Florida Power

CORPORATION
Crystal River Unit 3
Docket No. 98-302
Operating License No. DPR-72

November 24, 1998
3F1198-01

Subject: License Amendment Request #240, Revision 0
Addition of Safety-Related Diesel-Driven Emergency Feedwater Pump

Figure 1

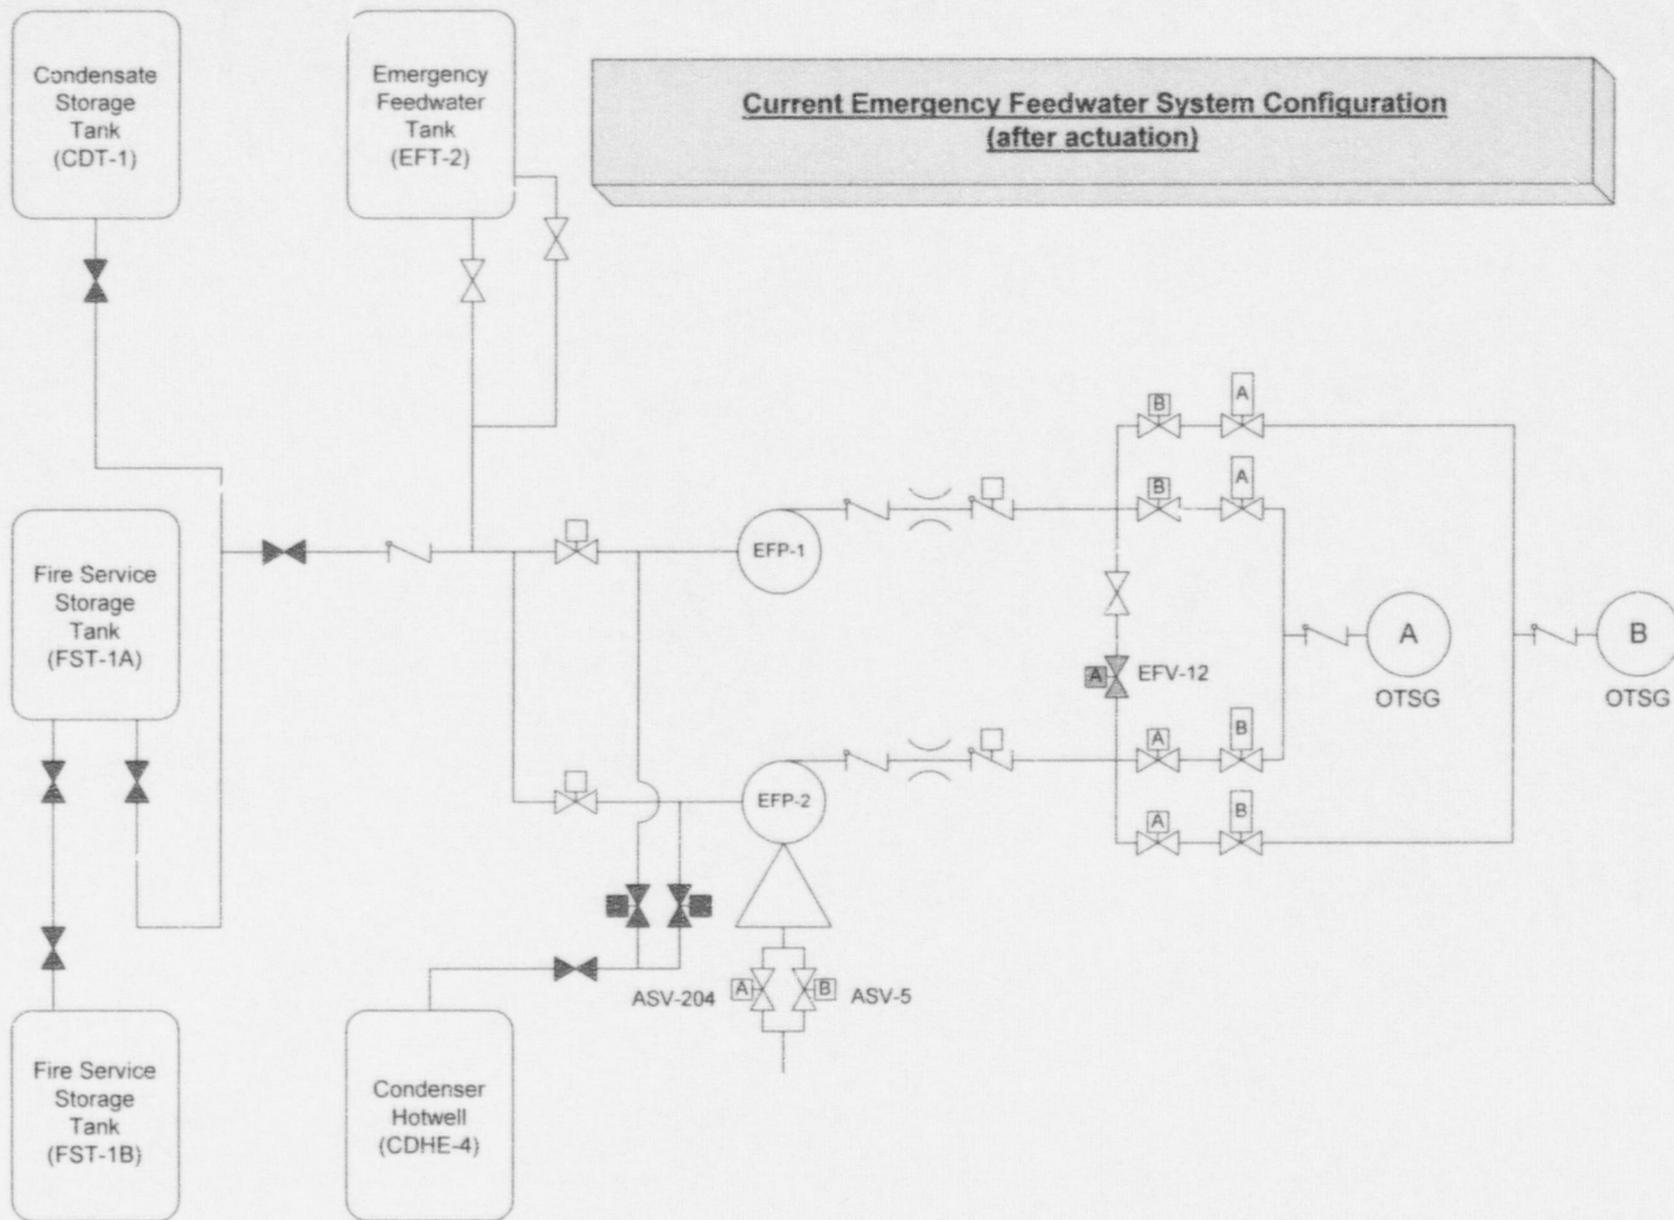
Background and Current Configuration (Refer to Figure 1, Page 8 of 9)

The motor-driven EFW pump (EFP-1) is powered from the "A" train 4160VAC emergency bus, which in turn auto-connects to the "A" train emergency diesel generator (EGDG-1A) during a LOOP. The steam driven EFW pump (EFP-2) receives steam from either or both steam generators through parallel block valves, ASV-204 and ASV-5. ASV-204 is an "A" train DC vital powered valve, while ASV-5 is a "B" train DC vital powered valve. Both valves receive an auto-open signal from the Emergency Feedwater Initiation and Control (EFIC) system should the demand for EFW exist. EFIC will start both EFW pumps if any of the following conditions exist:

Existing load limitations on EGDG-1A prohibit concurrent operation of EFP-1 with either: 1) the "A" train Decay Heat Pump (DHP-1A), which automatically starts on a Low Pressure Injection (LPI) actuation (reactor coolant system (RCS) pressure less than 500 psig) in the LPI mode¹, or 2) the "A" train Control Complex Chiller. Therefore, EFP-1 is interlocked with the LPI actuation such that an LPI actuation concurrent with a LOOP (EGDG-1A output breaker closed)

results in EFP-1 automatically tripping. For the purpose of this document, the described interlock will be referred to as the LPI/EFP-1 trip interlock.

Figure 2

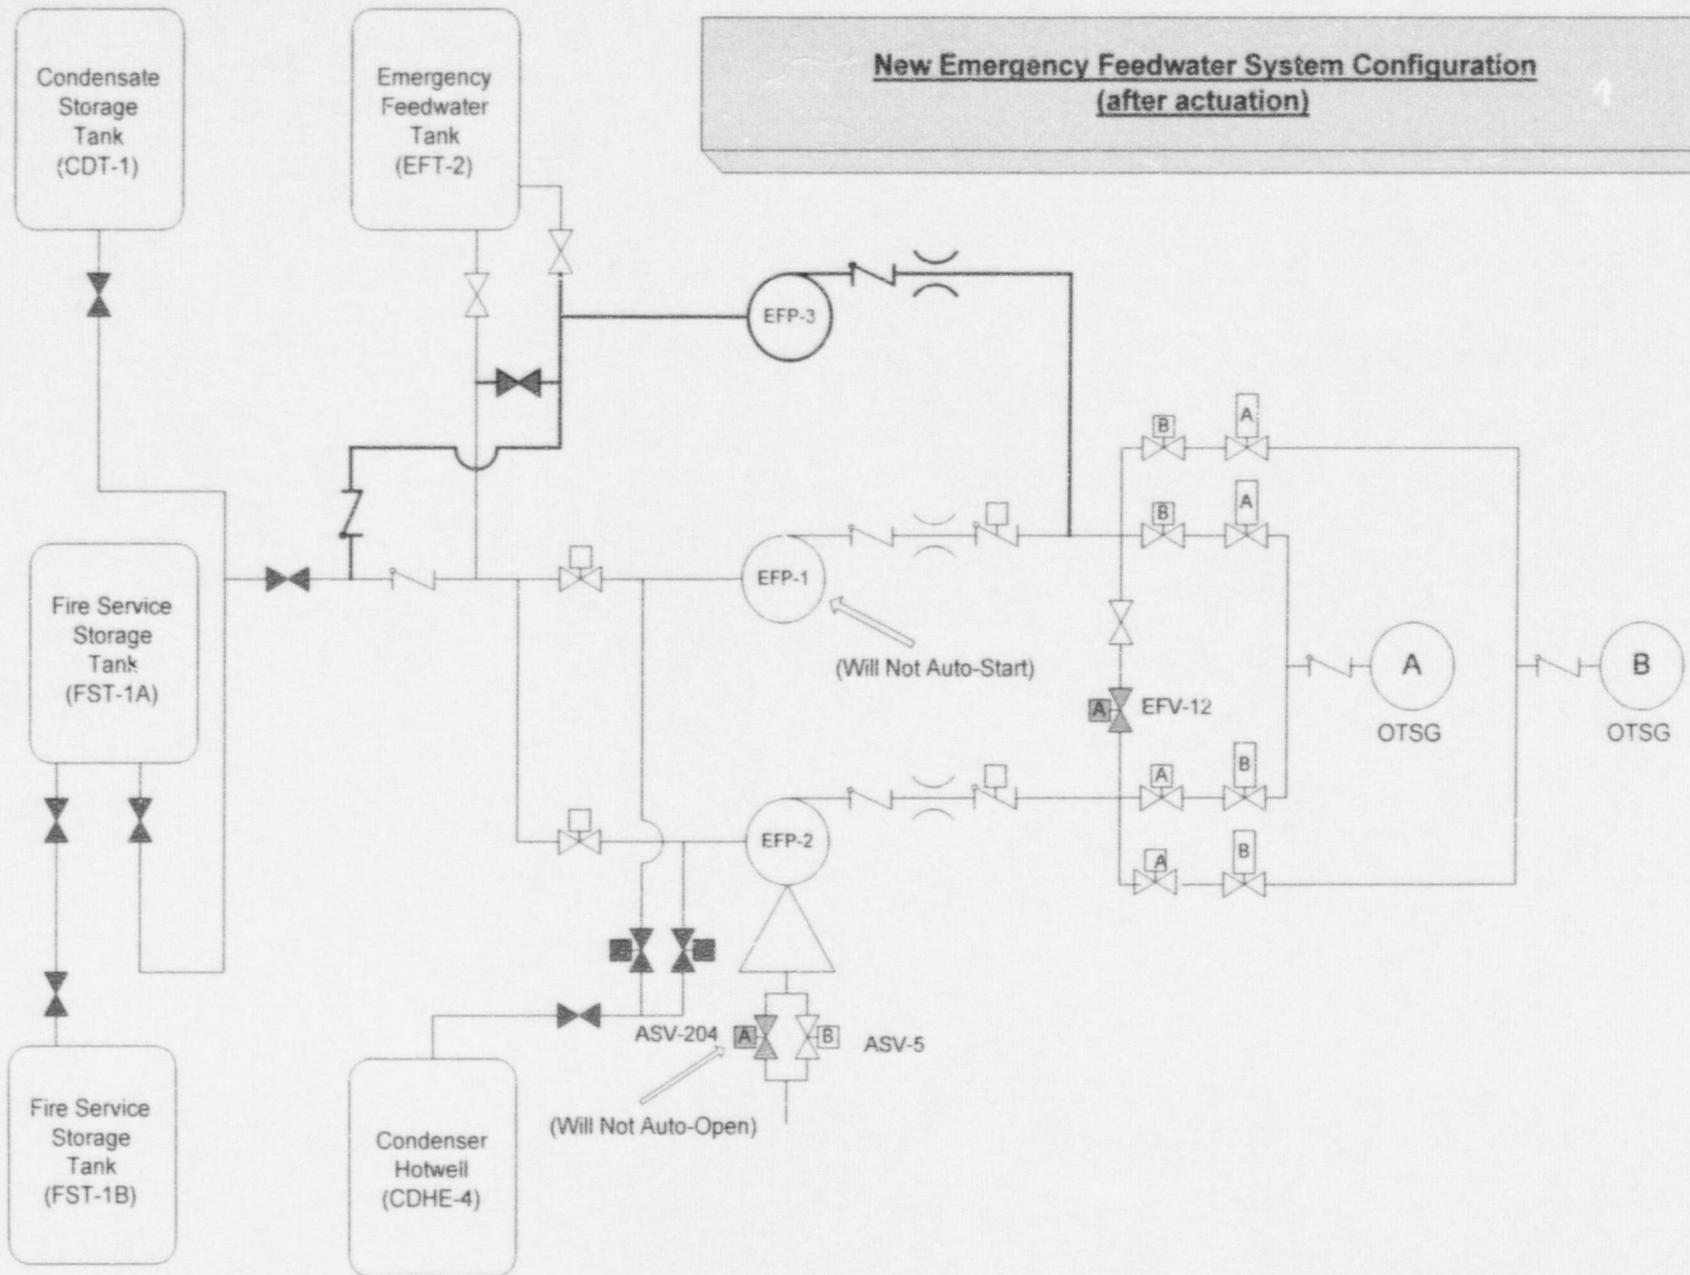
Discussion (Refer to Figure 2, Page 9 of 9)

Although successful accident management is supported by the current system configuration and EOP directed operator actions, improved accident management response will be achieved by the installation of several key EFW modifications:

- A new diesel-driven EFW pump (EFP-3) will be installed to functionally replace EFP-1.
- The auto-start logic will be removed from EFP-1.
- The auto-open logic will be removed from ASV-204.

EFP-3 will be installed as a functional replacement for EFP-1. EFP-3 will start and provide controlled and monitored EFW flow to both steam generators through the same EFW block and control valves as EFP-1 currently uses. Removing the auto-start logic from EFP-1 eliminates the need to perform EGDG-1A load management to accommodate ES loads required to mitigate design basis accidents. Therefore, operator actions to cross-tie EFW and stop EFP-1 for the LOBB scenario, or stop SWP-1A and RWP-2A for a failure of EFP-2, will no longer be required. EFP-1 will remain available as a manually started pump.

ASV-204 will no longer be required to open to mitigate a design basis accident. Credit for EFP-2 automatically starting to reduce load on EGDG-1A will not be required, since the auto-start feature for EFP-1 will be removed. As an added measure, the control switch for EFP-1 will be maintained in the pull-to-lock position during normal operation. With the removal of the auto-open signal from ASV-204, the overfill challenge during a failure of "B" DC electrical system is eliminated. ASV-204 will remain available as an "A" train powered motor operated valve, remotely operated from the control room.
